August 29, 2025

Richard Dwyer
Manager of Licensing
Nunavut Water Board

Re: Agnico Eagle's response to Meadowbank (2AM-MEA1530) and Whale Tail (2AM-WTP1830) 2024 Annual Report comments

Figure 6-1 from Appendix 14 (Whale Tail Site)

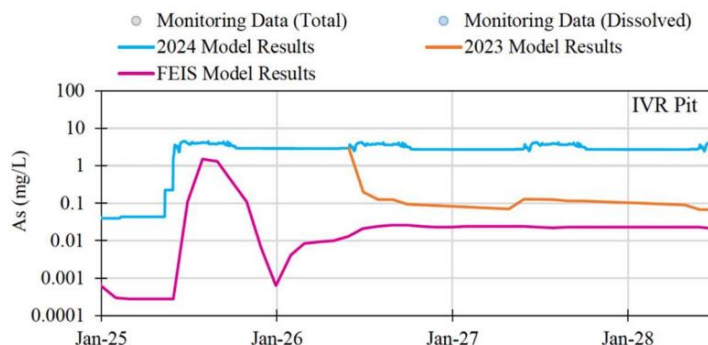
Comment: CIRNAC draws attention to the following three example figures:

In this case, the figure clearly demonstrates that there has been a wide range of water quality predictions throughout the evolution of the Whale Tail Project. At the right side of the figure, the current 2024 arsenic concentration predictions for the IVR Pit are approximately two orders of magnitude greater (i.e., 100 X) than what was predicted in the 2019 FEIS.

Agnico Eagle’s Response: *Agnico Eagle disagrees to the degree of uncertainty in the model. The differences between model outputs are not because of uncertainty, rather they are because of changes in water management strategy and movement of water, in particular, for Goose Pit and IVR Pit. For example, Figure 6-2 shows monitoring data compared with the 2023 and 2024 models. Generally, both water quantity (water levels) and water quality (concentration) are in agreement with monitoring results, and there is a high degree of certainty in model predictions.*

Figure 10 from the 2024 Annual Report (Meadowbank Site)

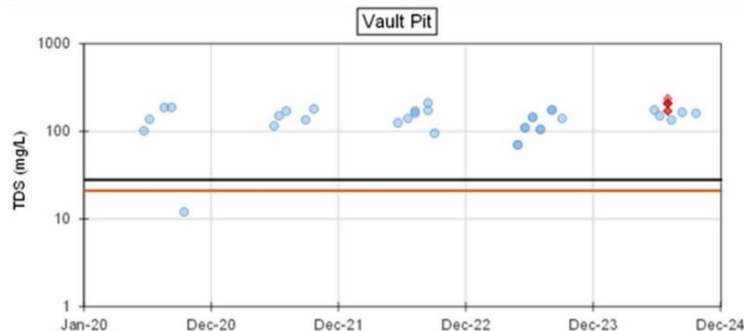
In this case, the figure illustrates that measured TDS concentrations in the Vault Pit are approximately one order of magnitude (i.e., 10x) greater than Agnico Eagle’s “poor end” prediction during the original Water Licence application.

Figure 11 from the 2024 Annual Report (Meadowbank Site)

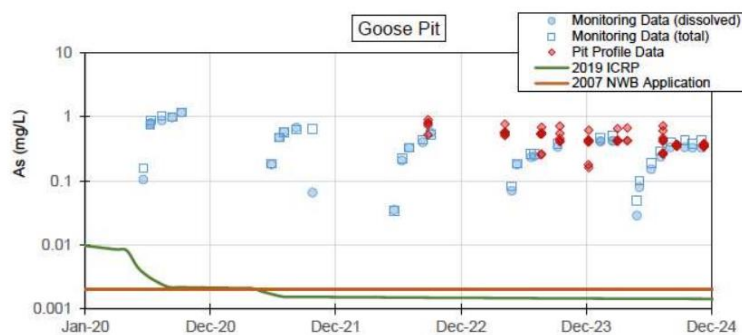
In this case, the figure shows that measured arsenic concentrations in Goose Pit are two orders of magnitude (i.e., 100x) greater than the most recent ICRP water quality predictions from as recently as 2019.

Figure 6-4 from Appendix 14 of the 2024 Annual Report

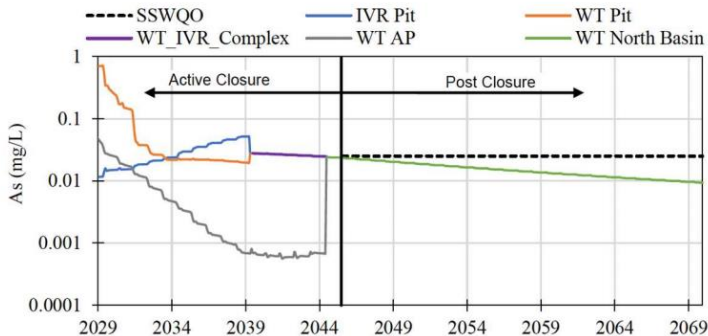
In this instance, arsenic concentrations in Whale Tail Lake are predicted to equal the Site-Specific Water Quality Objective (SSWQO) in 2044. On that basis, Agnico Eagle indicates that it will reconnect the pit lake to the receiving environment, and the post-closure phase will begin immediately afterward. Taking into consideration the uncertainty associated with model predictions (as noted above), CIRNAC considers it inappropriate to make closure decisions without any “margin of error”. Instead, CIRNAC’s position is that closure decisions should be based on a more conservative set of assumptions regarding future water quality, taking into account the accuracy of past predictions.

Recommendation (R-04): CIRNAC recommends that Agnico Eagle perform quantitative sensitivity analyses of their water quality predictions. The analyses should quantify potential variability in all major source terms and associated pathways (e.g., elevated arsenic seepage from pit walls, waste rock storage facilities (WRSFs) and mine areas). CIRNAC acknowledges that some sensitivity analyses have already been performed in prior predictions, but a more comprehensive analysis of all variables is justified. The additional information is necessary to verify Agnico Eagle’s conclusion that their modelling results are conservative and overpredict any potential impacts. Results from past predictions demonstrate that this is not the case.

Regarding Figure 6-4, the ICRP states that active closure period is defined by the period until which water quality in Whale Tail North Basin meet CCME or SSWQO guidelines. In this case, the parameter of concern is arsenic, and the guideline is a SSWQO of 0.025 mg/L for total arsenic. This is the criteria for defining when post-closure period begins. Post-closure period cannot begin unless

all parameters meet CCME or SSWQO guidelines, including arsenic. As noted above, Agnico Eagle disagrees with the conclusion of the degree of uncertainty in model predictions. Regardless, if SSWQO for arsenic are not met, Agnico Eagle will continue with active closure water management practices.
